ATR on Quality Control Check Report. (Apartments)

Quality Control Check Report. Stage: After Finishing Stage III (Apartments)			
Flat No	G-306	Other	
Company	MRM-CLLP	Project	-
Prepared by	P. Bhaskar	Sign	GMR
Project Manager	Narendran K	Sign	<i>[Signature]</i>
Previous stage report no.		41382	Report filed and signed by PM
Checked By MD on			04-12-23
			04-12-23
			☒ Yes ☐ No
			☐ Yes ☐ No

Gulmohar Residency

Flat No	306	Block no.	' G '
Flat Area	1360 sqft	Type	Deluxe / Luxury
Buyer Name	Sreekar Aslesha Suri		
Phone No.	9959097184	Email

Description	Direction	Owners & Developers	Date	Promoted by
WORKING PLAN-1360 SII-A1 TYPE	N	Modi Reality Mallapur LLP	25.09.2020	Modi Properties Pvt Ltd
		Project Name & Phase	Prepared By	
		Gulmohar Residency	Approved By	
			Scale	Phone: +91-40-66335551

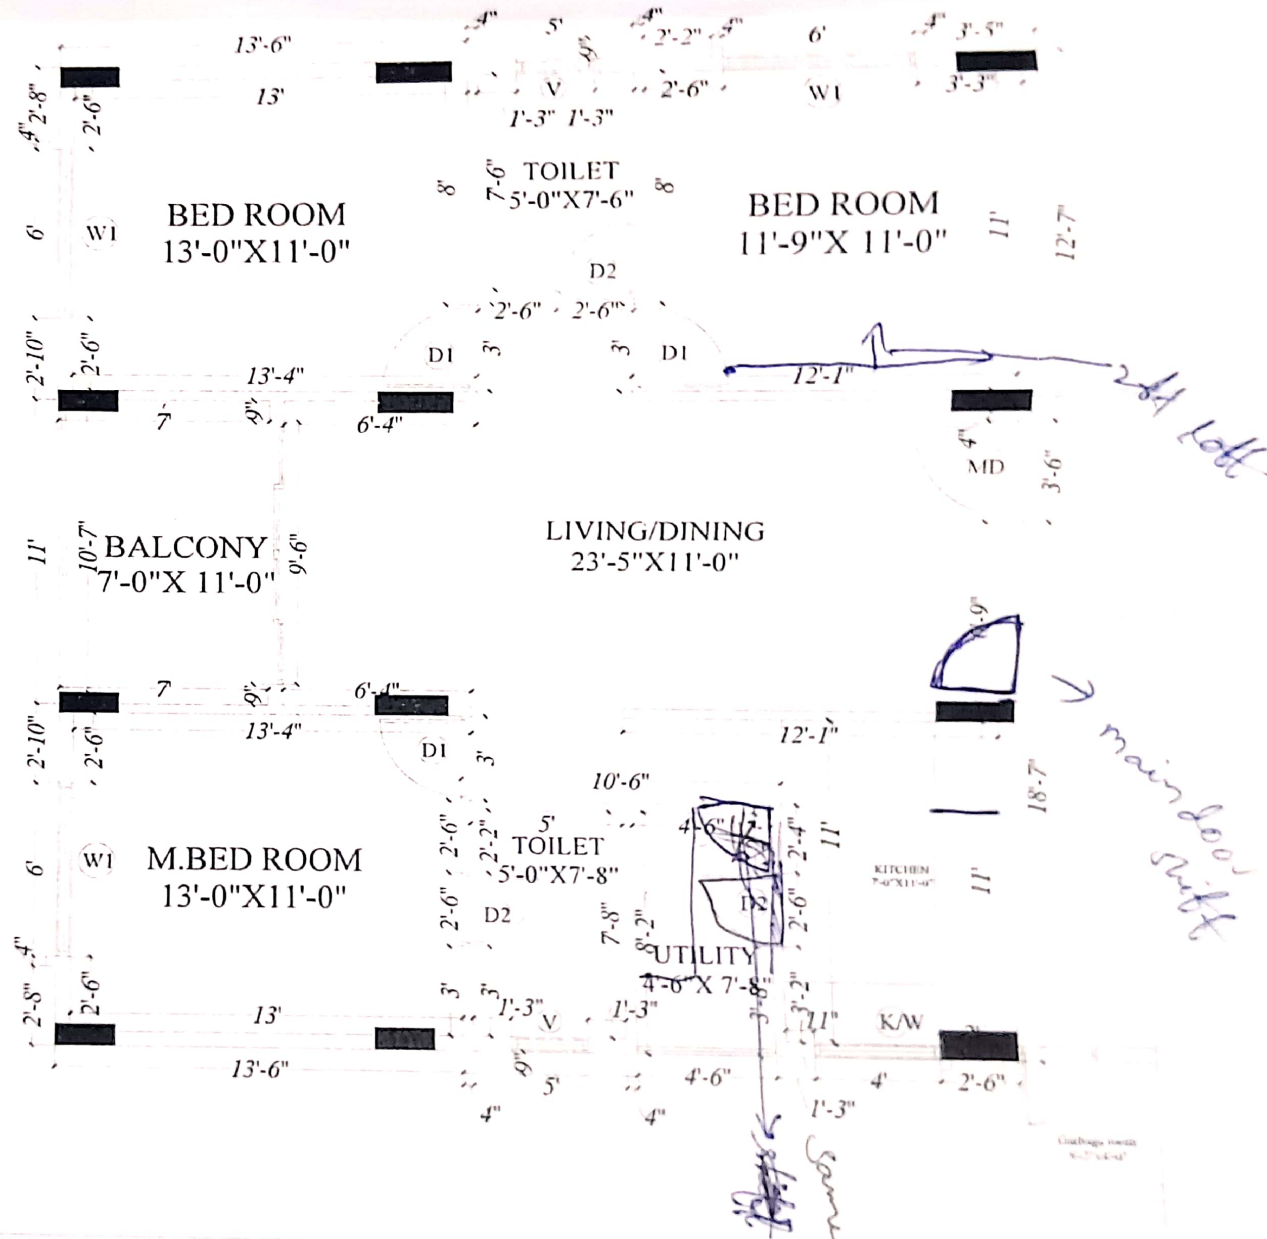
① all doors should be polished (chocolate colour) including window sashes.

② in ~~the~~^{C.T} Bathrooms ledge well top one more extra granite required.
